Product Change Notification

Product Change Notification: E-17-005334

DEUTSCH DTF15-12PX, DTF15-12PX-G003 12 WAY RECEPTACLE, DTF Series

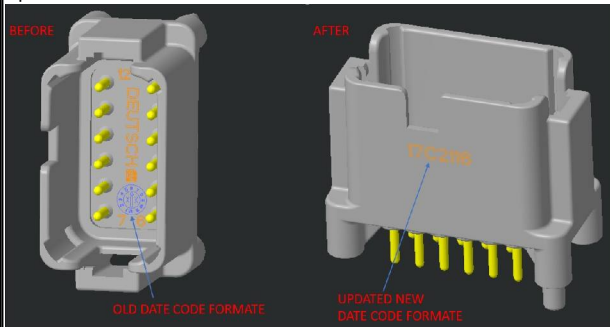
Date code location and format change to improve connector traceability. See photos below

Updated new Date code formate

Product Improvement. Dear customer, we are contacting you to notify you of a form change in DTF15-12PX, DTF15-12PX-G003 product datecode marking. This change is to improve connector traceability . IMPORTANT: This is a continual improvement so the current and previous revisions of these parts can be used interchangeably in the field. These changes are being phased in gradually and previous revision can remain stocked until use. Product drawing is affected and will be updated.
